STAFF ITEM

SUBJECT: Revision to approved HAWP (Case 37/03-06B) for a two story rear addition at 7710 Takoma Avenue, Takoma Park, a Contributing Resource within the Takoma Park Historic District

DATE: May 18, 2010

HISTORIC PRESERVATION COMMISSION STAFF REPORT

SIDE ELEVATION (PROPOSED)

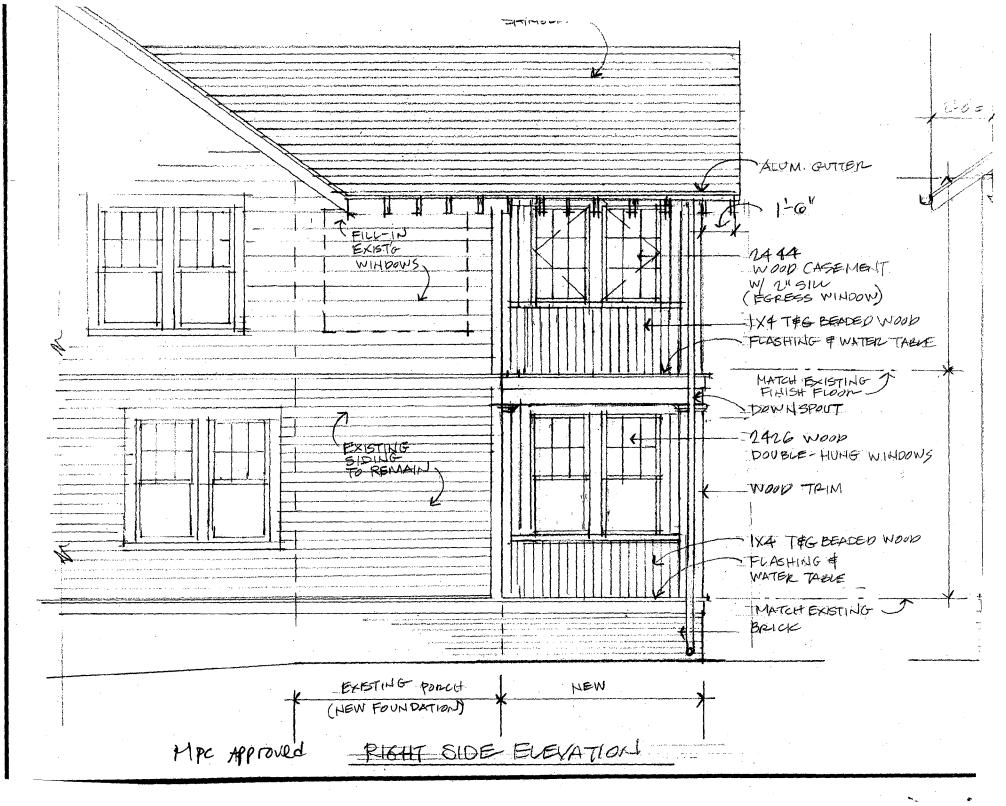
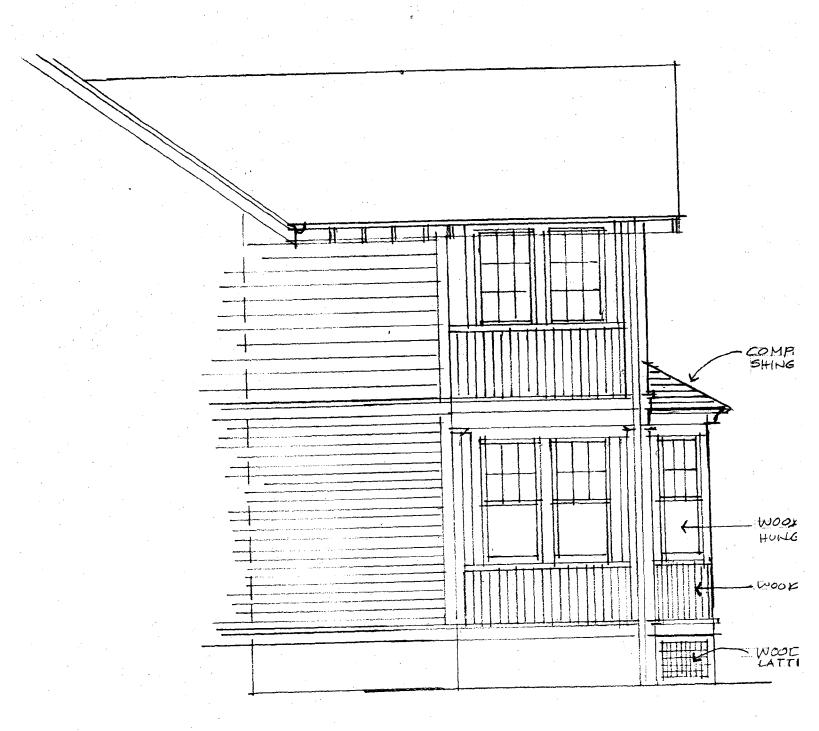
REVISED PROPOSAL: The applicant is requesting approval to replace a lattice enclosure around existing below grade basement steps with a wood inset picket railing to match the existing railing.

the said can be approved at staff level

STAFF RECOMMENDATION: Staff is recommending that the HPC approve the revised proposal.

REAR ELEVATION (proposo)

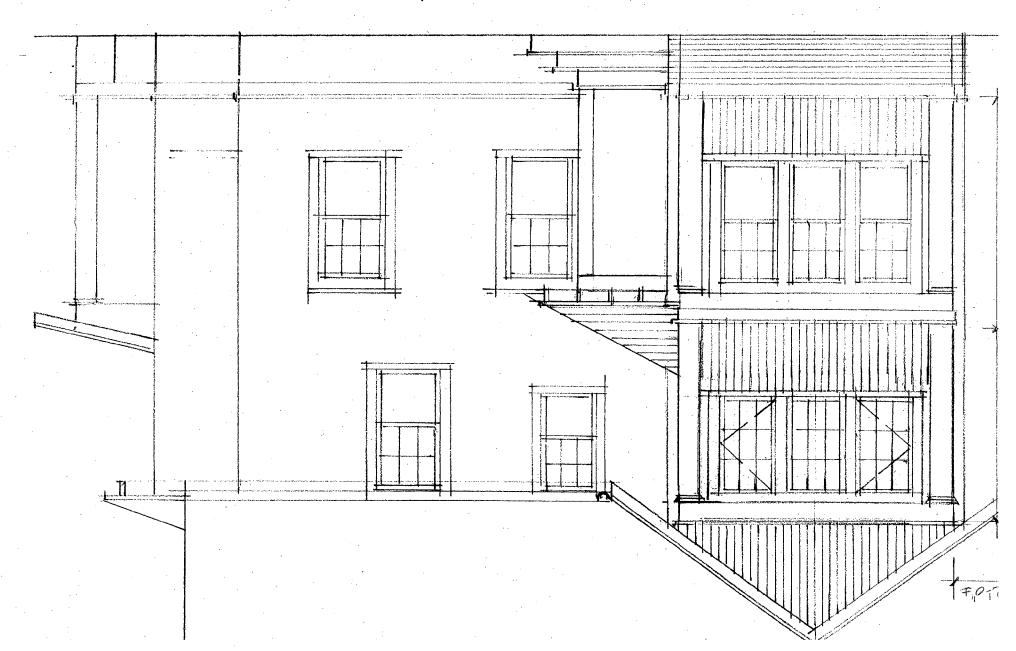
HOC approved

PROPOSED REAR ELEVATION

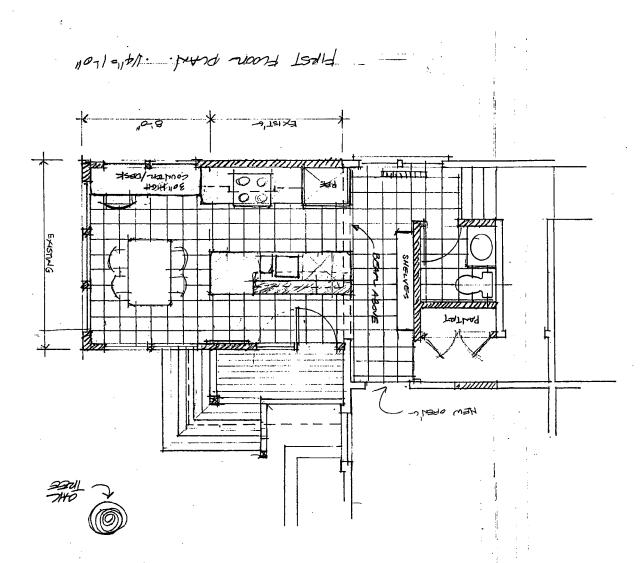
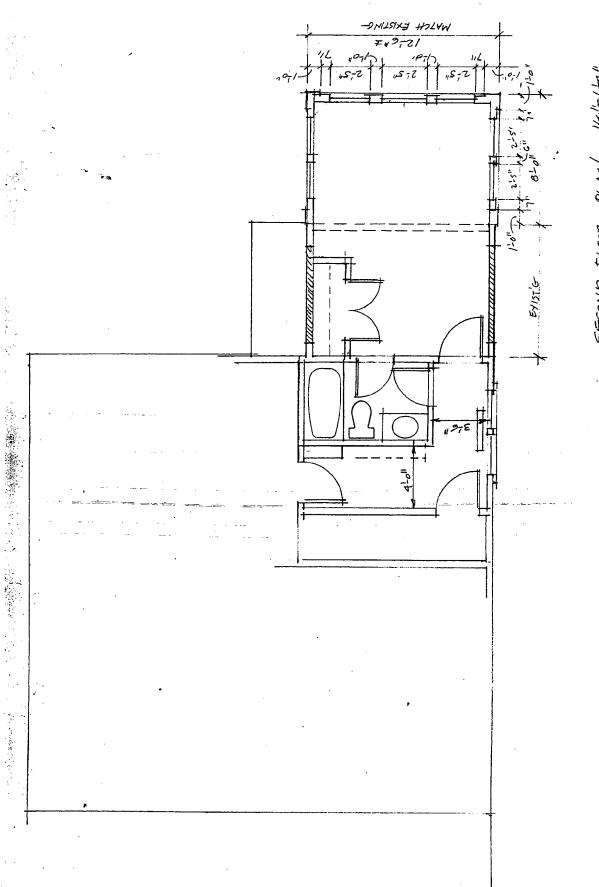
- Second From prod 14"
